AMENDMENT C141 DRAFT UPPER GULLY STRATEGIC PLAN - SUBMISSIONS AND RESPONSES SUMMARY TABLE

KNOX PLANNING SCHEME

EXPLANATORY REPORT

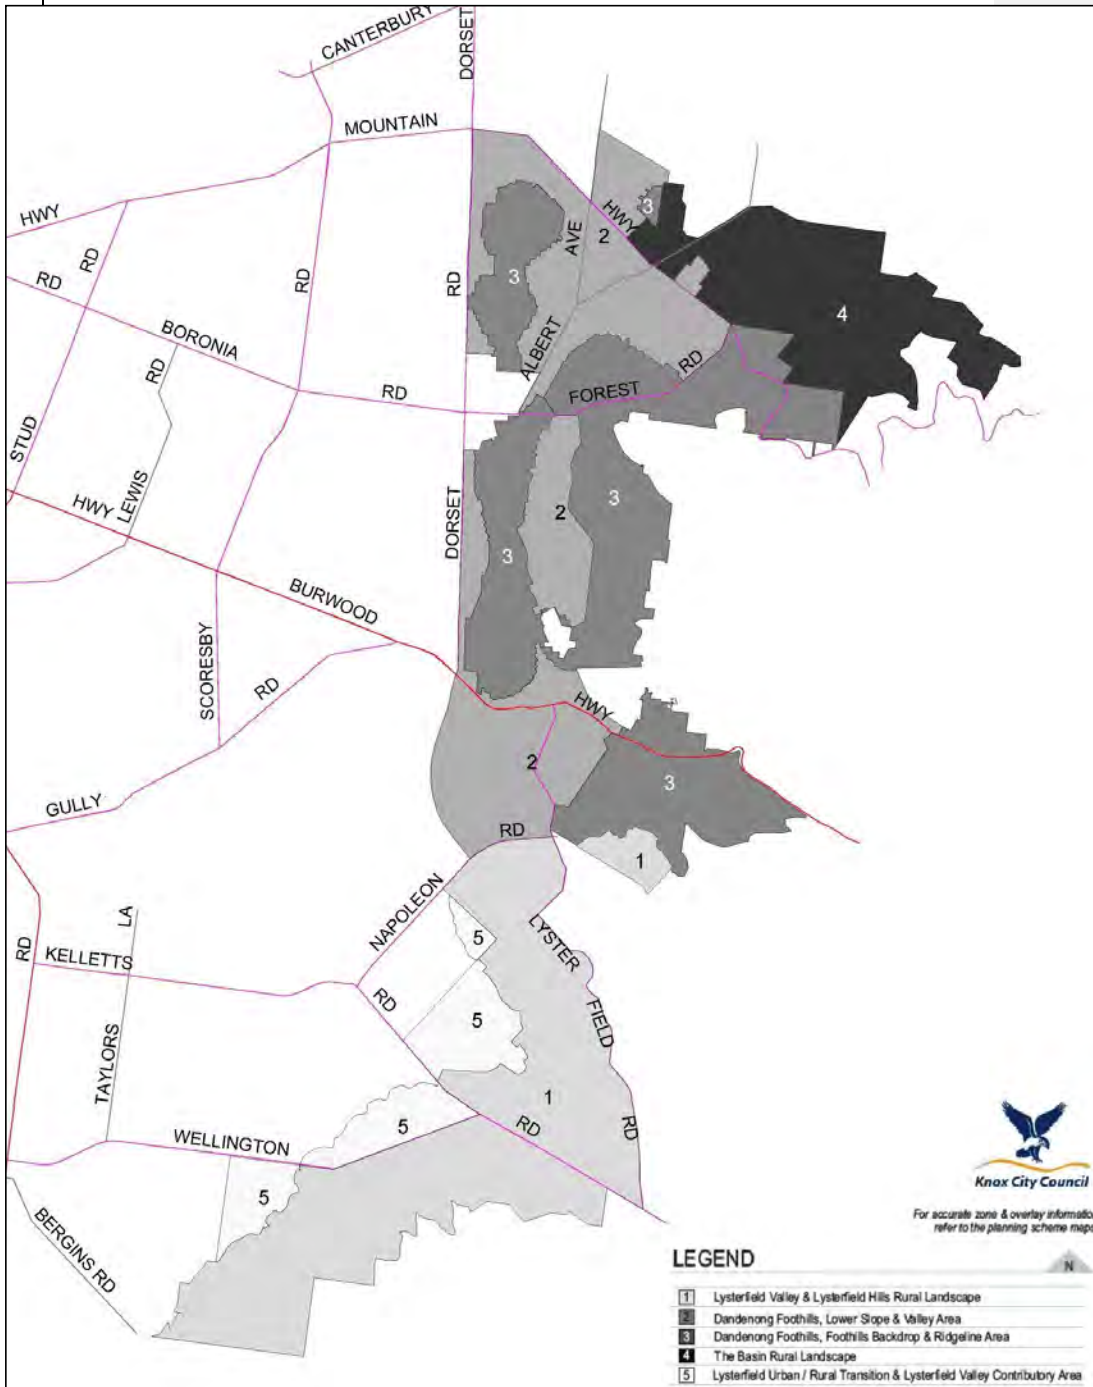
Comment [11]: Delete map

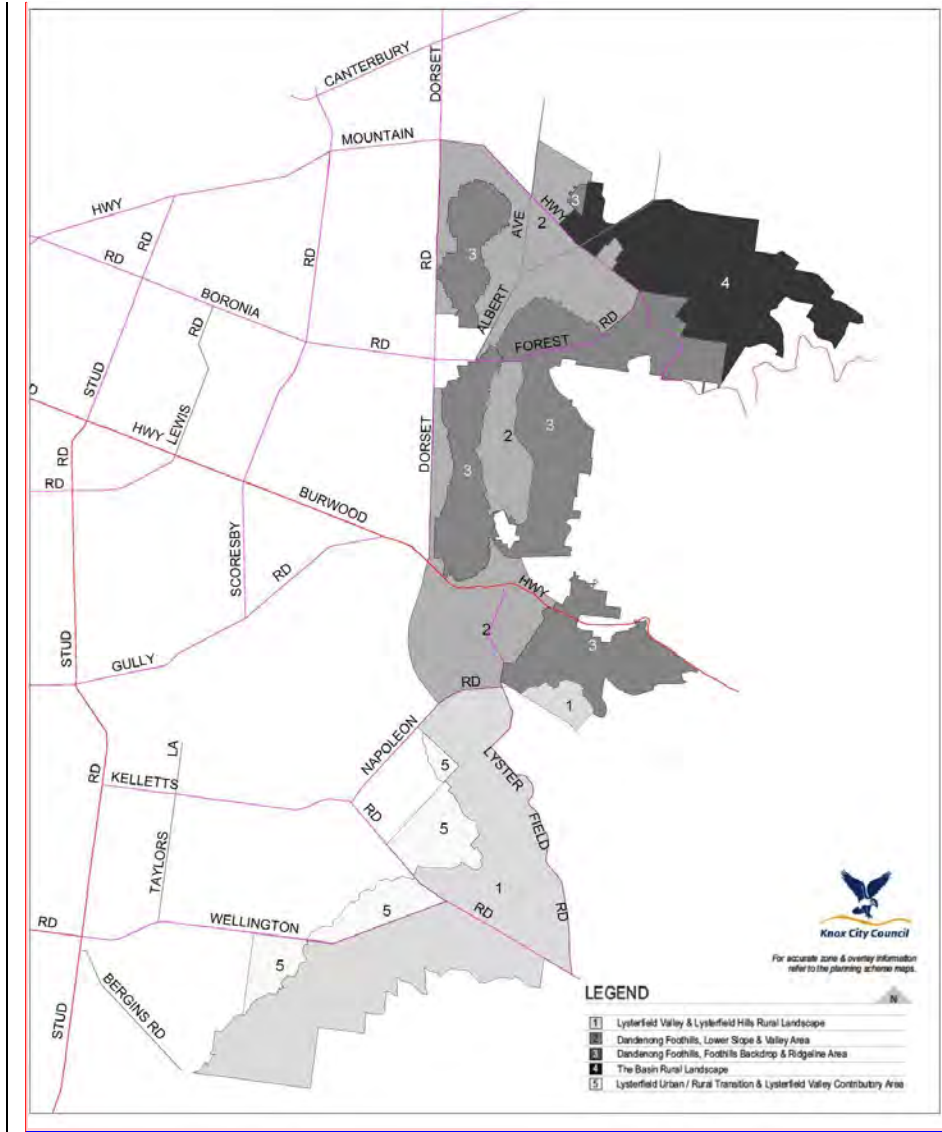
Comment [12]: Insert new map with 'cut out' for Upper FTG

Map 1 – Building Heights & Setbacks

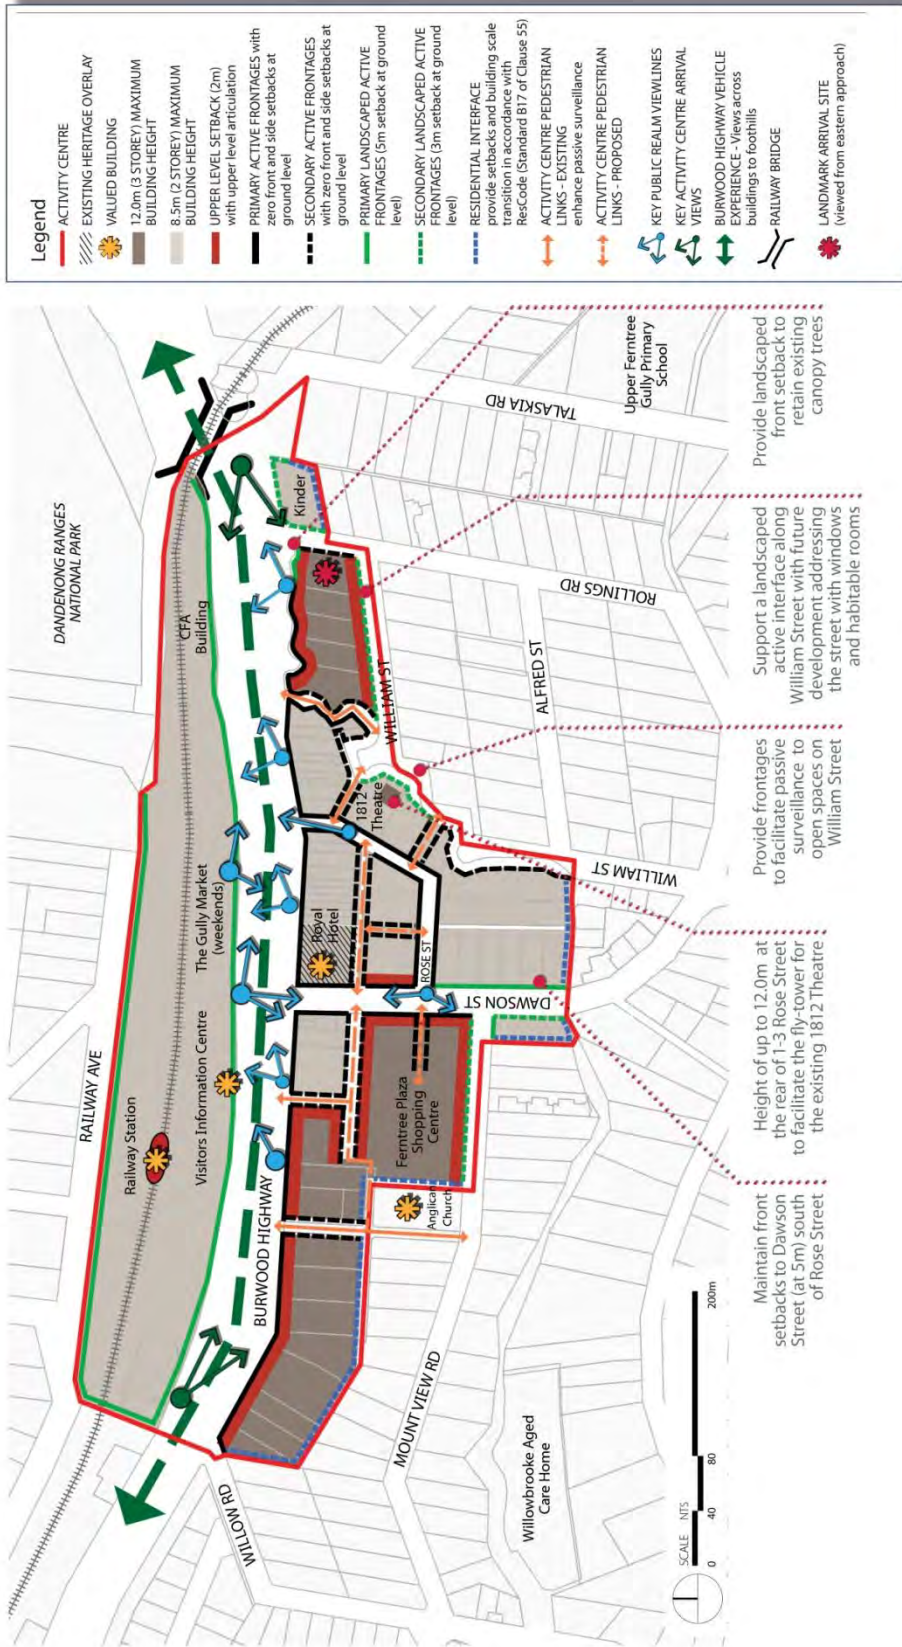
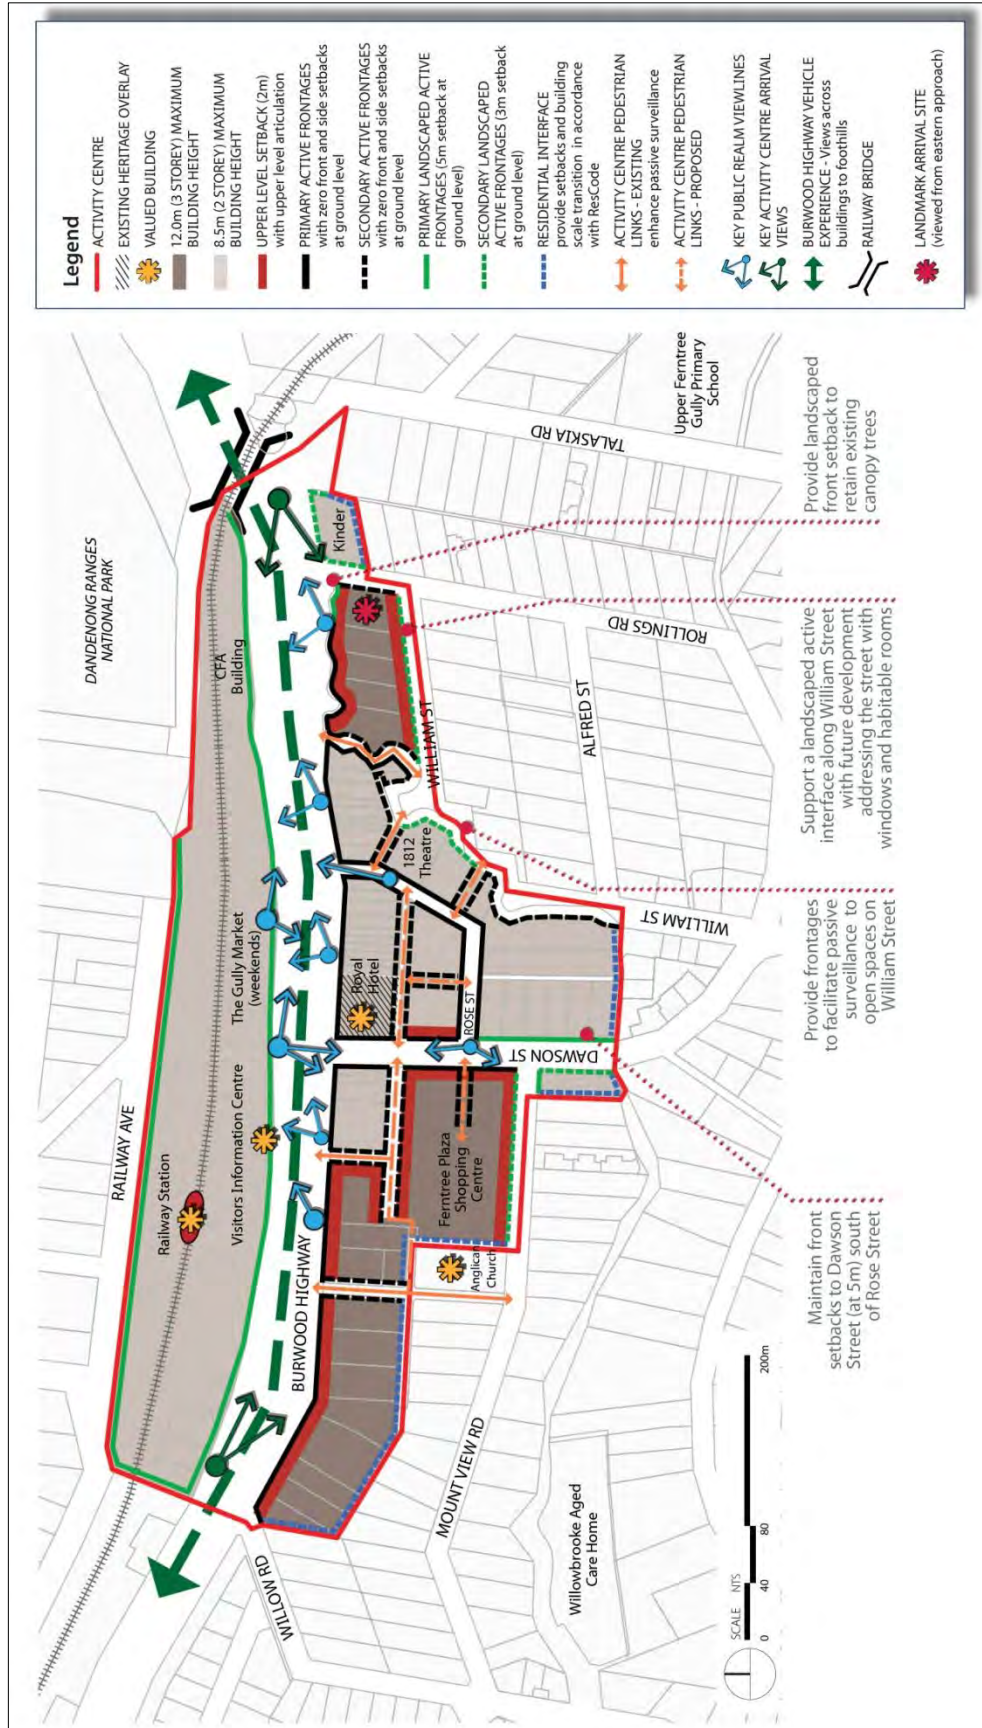
No.	Submission Source	Submission Summary	Submission Discussion and Recommendation
189 A, B, C	Individual	<p>1. Objects to the Kindergarten at 1 Rollings Road being included within the Activity Centre.</p> <p>2. Objects to 2 storey (8.5m) height limit for 1 Rollings Road on the basis that it will impact on their privacy at their property 4-6 Rollings Road.</p> <p>3. Supports 2 storey height limits within the Activity Centre for properties that have a Burwood Highway frontage only (and excluding 1 Rollings Road).</p>	<p>1. Noted - No change. The boundary of the Activity Centre has not been altered as part of Amendment C141. The Activity Centre includes land zoned for Commercial 1 Zone, Road Zone 1, Public Use Zones and Residential Zone.</p> <p>2. Noted - Changes proposed DDO12 proposes to protect residential amenity (including privacy and overshadowing) through the application of a Residential Interface that requires side and rear setbacks in accordance with Standard B17, Clause 55 of ResCode. The impact of future building heights on a number of important views from the public realm was tested through 3D modelling.</p> <p>Recommendations:</p> <p>2a. Amend DDO12 Map 1 - Building Heights and Setbacks to incorporate reference to ResCode "Standard B17 of Clause 55" into the legend.</p> <p>2b. Amend Strategic Plan Map 15 – Preferred Setbacks and Design Outcomes for Built Form to incorporate reference to ResCode "Standard B17 of Clause 55" into the legend.</p> <p>2c. Amend LPP 22.14 Map 1 – Activity Centre Framework Plan to incorporate reference to ResCode "Standard B17 of Clause 55" into the legend.</p> <p>3. Support noted.</p>

No.	Submission Source	Submission Summary	Submission Discussion and Recommendation
			2. No change. Refer to point 1.
204	Individual	<p>1. Objects to 3 storey (12m) and 2 storey (8.5m) maximum building heights in the Activity Centre on the basis of impacting on privacy, protecting viewlines to the hills, and will increase the traffic, pollution and rubbish in the area.</p> <p>2. Objects to any proposal to allow dual occupancy dwellings or units of any kind in the area.</p>	<p>1. Noted - Changes proposed.</p> <p>The draft Strategic Plan seeks to provide a balance between maintaining the village character and public realm viewlines, land use, economic and building development opportunities appropriate for an activity centre with a railway station in the foothills of the Dandenong Ranges.</p> <p>While the proposed building heights of 8.5m and 12.0m are greater than existing interim building heights controls of 7.5m they provide scope for increased floor to ceiling heights on both the ground floor level and upper level of buildings and would enable retail or commercial uses on both levels. This would support a range of business opportunities within the Activity Centre, accommodate a variety of residential, retail of commercial uses, allow for enhanced building amenity (increased light, improved natural ventilation and reduced heat gain), and allow for articulated roof forms and flooding requirements.</p> <p>The impact of future building heights on a number of important views from the public realm was tested through 3D modelling. The sites for three storey maximum building heights were identified by Council and determined to have some, however minimal impact on key public realm viewlines and could still enable the 'village feel' of the Activity Centre to be maintained.</p> <p>The Technical Report: Transport and Parking (Movendo 2015) did not identify any traffic capacity issues. It also makes recommendations to improve traffic movements around the centre. Incremental residential growth in the centre is unlikely to have significant impact on traffic volumes. Any impacts can be managed as they arise by VicRoads and Council.</p> <p>DDO12 proposes buildings that provide a high level of internal amenity through a number of measures including facilitating sunlight penetration as noise attenuation. These measures can also reduce greenhouse gas emissions, power consumption, water usage and waste, and help to protect water quality and therefore reduce pollution in the area. Increases to rubbish will be managed by Council.</p> <p>DDO12 proposes to protect residential amenity (including privacy and overshadowing) through the application of a Residential Interface that requires side and rear setbacks in accordance with Standard B17, Clause 55 of ResCode.</p> <p>Recommendations:</p> <p>1a. Amend DDO12 Map 1 - Building Heights and Setbacks to incorporate reference to ResCode "Standard B17 of Clause 55" into the legend.</p> <p>1b. Amend Strategic Plan Map 15 - Preferred Setbacks and Design Outcomes for Built Form to incorporate reference to ResCode "Standard B17 of Clause 55" into the legend.</p> <p>1c. Amend LPP 22.14 Map 1 – Activity Centre Framework Plan to incorporate reference to ResCode "Standard B17 of Clause 55" into the legend.</p>

No.	Submission Source	Submission Summary	Submission Discussion and Recommendation
		access for the Ferny Creek Trail.	slightly raised to create some sound within the car and provide a visual aid to alert the driver. They are not considered severe enough to create excessive noise and are similar to travelling over other raised line marking at school crossings or stop lines.
219	Individual	1. Objects to 3 storey (12m) maximum building height in the Activity Centre on the basis of, increase of traffic and noise, overshadowing on existing residential areas surrounding the Activity Centre and protecting the natural context of the area and views to the foothills.	<p>1. Noted - Changes proposed. The draft Strategic Plan seeks to provide a balance between maintaining the village character and public realm viewlines, land use, economic and building development opportunities appropriate for an activity centre with a railway station in the foothills of the Dandenong Ranges. The impact of future building heights on a number of important views from the public realm was tested through 3D modelling. The sites for three storey maximum building heights were identified by Council and determined to have some, however minimal impact on key public realm viewlines and enable the 'village feel' of the Activity Centre to be maintained</p> <p>The Technical Report: Transport and Parking (Movendo 2015) did not identify any traffic capacity issues. It also makes recommendations to improve traffic movements around the centre. Incremental residential growth in the centre is unlikely to have significant impact on traffic volumes. Any impacts can be managed as they arise by VicRoads and Council.</p> <p>DDO12 proposes to protect residential amenity (including privacy and overshadowing) through the application of a Residential Interface that requires side and rear setbacks in accordance with Standard B17, Clause 55 of ResCode.</p> <p>Recommendations:</p> <p>1a. Amend C141 DDO12 Map 1 - Building Heights and Setbacks to incorporate reference to “Standard B17, Clause 55 of ResCode” into the legend.</p> <p>1b. Amend Strategic Plan Map 15 - Preferred Setbacks and Design Outcomes for Built Form to incorporate reference to ResCode “Standard B17 of Clause 55” into the legend.</p> <p>1c. Amend LPP 22.14 Map 1 – Activity Centre Framework Plan to incorporate reference to ResCode “Standard B17 of Clause 55” into the legend.</p>

No.	Submission Source	Submission Summary	Submission Discussion and Recommendation
			<p>1a. Amend DDO12 Map 1 - Building Heights and Setbacks to incorporate reference to ResCode “Standard B17 of Clause 55” into the legend.</p> <p>1b. Amend Strategic Plan Map 15 – Preferred Setbacks and Design Outcomes for Built Form to incorporate reference to ResCode “Standard B17 of Clause 55” into the legend.</p> <p>1c. Amend LPP 22.14 Map 1 – Activity Centre Framework Plan to incorporate reference to ResCode “Standard B17 of Clause 55” into the legend.</p>
226	Individual	<p>1. Objects to 3 storey (12m) maximum building height in the Activity Centre on the grounds of traffic and car parking demands, inconsistent with community consultation, and blocking views to the Dandenong Ranges.</p>	<p>1. No change.</p> <p>The draft Strategic Plan seeks to provide a balance between maintaining the village character and public realm viewlines, land use, economic and building development opportunities appropriate for an activity centre with a railway station in the foothills of the Dandenong Ranges.</p> <p>The impact of future building heights on a number of important views from the public realm was tested through 3D modelling. The sites for three storey maximum building heights were identified by Council and determined to have some, however minimal impact on key public realm viewlines and could still enable the ‘village feel’ of the Activity Centre to be maintained.</p> <p>The Technical Report: Transport and Parking (Movendo 2015) did not identify any traffic capacity issues. It also makes recommendations to improve traffic movements around the centre.</p> <p>Incremental residential growth in the centre is unlikely to have significant impact on traffic volumes. Any impacts can be managed as they arise by VicRoads and Council.</p> <p>The Technical Report: Transport and Parking (Movendo 2015) also identifies parking capacity issues and makes recommendations to improve car parking around the centre. These recommendations have been implemented into the Strategic Plan.</p> <p>Clause 52.06 outlines the requirements for car parking provision across the municipality and applies to the Activity Centre. The clause ensures the provision of an appropriate number of car parking spaces having regard to the demand likely to be generated from development, the activities on the land and the nature of the locality.</p> <p>In regards to the three storeys not supported through community consultation, this is noted.</p>
